**NSLPP MEETING HELD ON 7/02/24****Attachments:**

ADDRESS/WARD: 115 Blues Point Road, McMahons Point 2060 (L/E)**APPLICATION No:** DA 205/23**PROPOSAL:** Alterations and additions to a dwelling including new lift, formal vehicular access from lane, and new landscaping**PLANS REF:**

OWNER: Bruce MacLean Smith & Lauren Ann Smith**APPLICANT:** Felicity King**AUTHOR:** Report of Rachel Wu, Graduate Assessment Officer**DATE OF REPORT:** 16 January 2024**DATE LODGED:** 7 July 2023**DATE AMENDED:** 31 October 2023; 17 January 2024**RECOMMENDATION:** Approval, subject to conditions

Figure 16/17: Photographs of front façade provided in the heritage impact statement of DA200/07

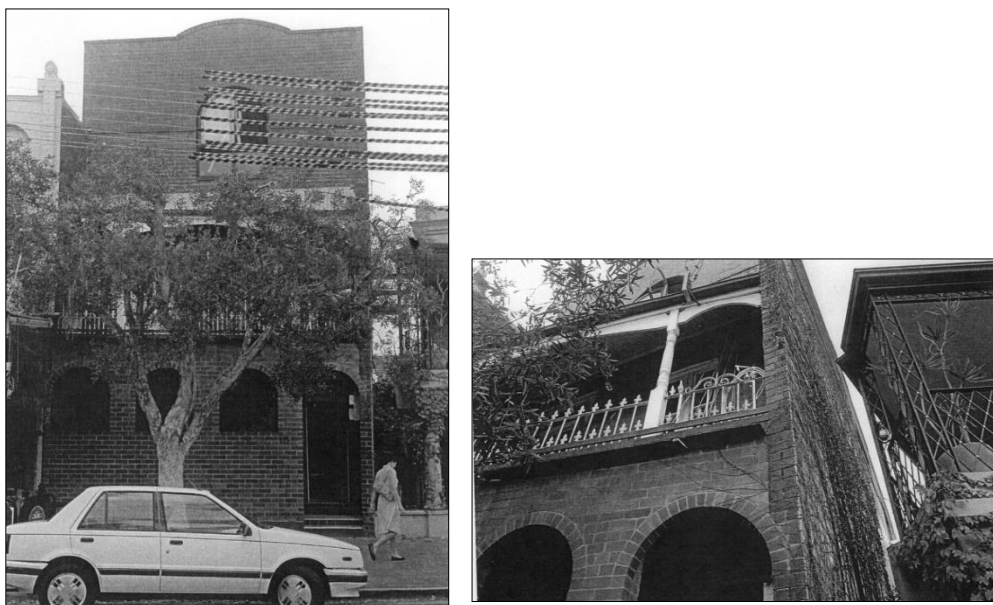
The ground floor facing Blues Point Road had a brick wall built on the front boundary and that the original cast iron fence and gate had been relocated to form a balustrade to the first-floor balcony. Substantial alterations were carried out under DA200/07 that removed the unsympathetic fabric and enhanced the aesthetic value of the building to both Blues Point Road and Wellington Lane by reconstruction of the verandah to the western elevation of the building to Blues Point Road; replacing the ‘unsympathetic side accretions’ with a pergola and new storage to the Wellington Lane elevation; and a parapeted carport with a garden setting.

The works to the rear maintained the existing envelope and overall footprint of the building. The brick portal frame to the carport and roller shutter door as approved under the DA no longer exist and the storage has been modified. Window and door openings were conditioned to be timber-framed not aluminium to remain consistent with the style of the building and the character of buildings in the surrounding conservation area.

Figure 19: Area of design amendments reflecting the recommended condition and shown on section

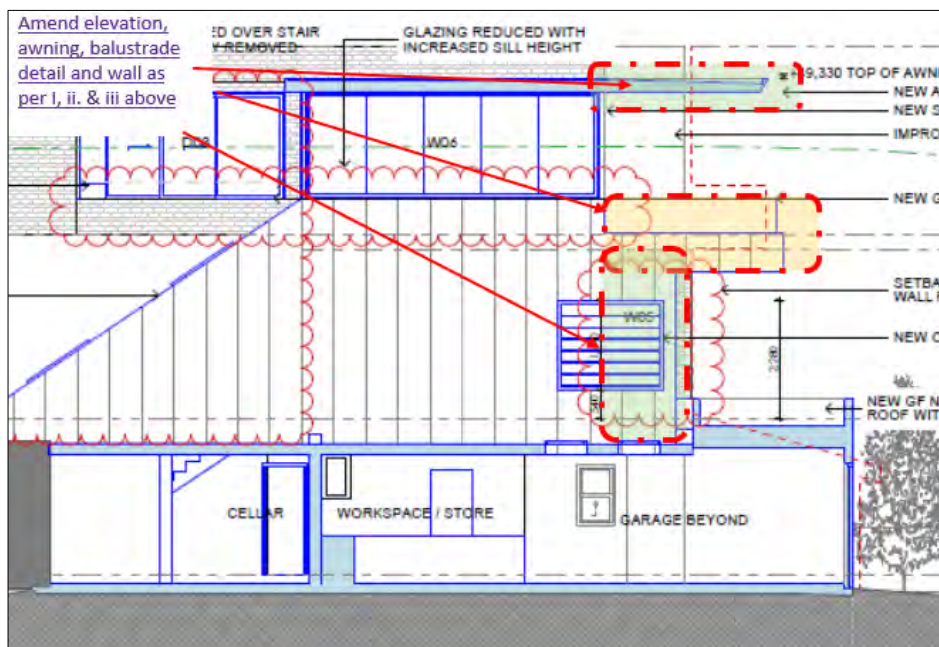
- C18. The plans referred to in condition A1 are to be amended to provide for the following changes:
- i. The proposed second floor balcony and awning are to be reduced in width to match the width of the existing rear wing;

Figure 22: Extract from section showing proposed breach.

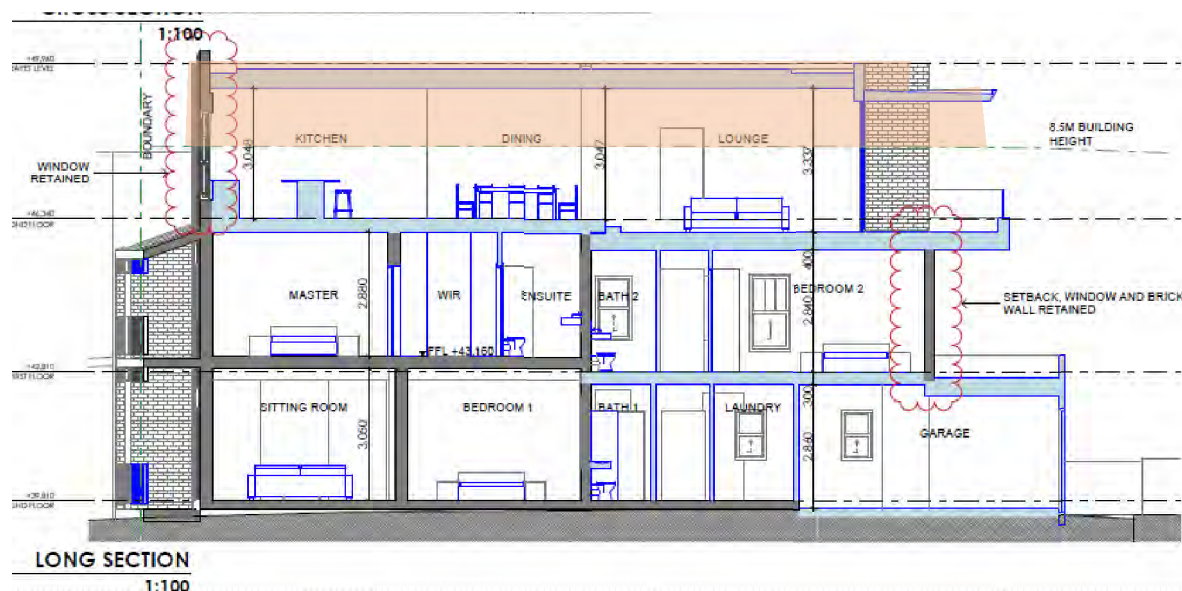
The proposed works would have a height of 10.4m that fails to comply with the permissible height limit of 8.5m in accordance with clause 4.3 in NSLEP 2013 and creates a variation from the HOB control of 1.9m or 22.35%. The measurements are taken from the proposed Long Section from the natural ground floor (existing) to the roof solar panels.

The existing building has a maximum height of 10.8m from the natural ground floor (existing) to the roof parapet. The proposal is lower than the maximum height of the building. In considering the breach to the height standard, Council identified the height of proposed works above the height standard as well as the existing height of the building, which is substantially above the maximum 8.5metre control. The works in breach of the height standard consist of the following:
